CITY OF ALBUQUERQUE

**Re: Zia Auto Remodel
4913 Menaul Blvd.
Traffic Circulation Layout
Architect's Stamp 01-24-18 (H17-D114)**

DRAINAGE AND TRANSPORTATION INFORMATION SHEET (REV 1/2016)

SITE PLAN / TRAFFIC CIRCULATION LAYOUT

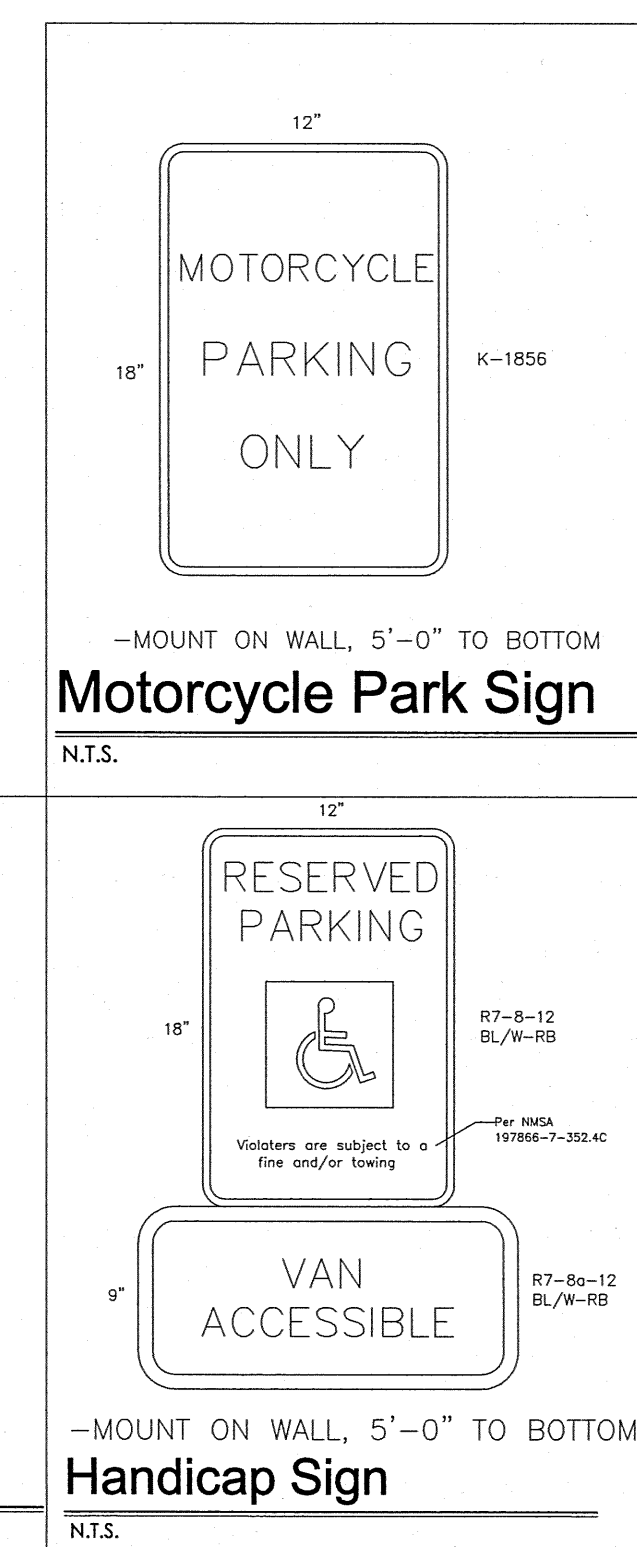
1. A scale of 1"=20' is recommended for sites less than 5 acres.
2. Dumpster apron cannot extend into the alley.
3. Label the compact parking spaces by placing the words "**COMPACT**" on the pavement of each space.
4. One-way vehicular paths require pavement directional signage and a posted "**Do Not Enter**" sign at the point of egress. Please show detail and location of posted signs.
5. Please provide the widths of the existing drive entrances.
6. Lot line should not cross through buildings; DRB may be needed for re-plotting. Please check with zoning if the lot lines need to be removed.
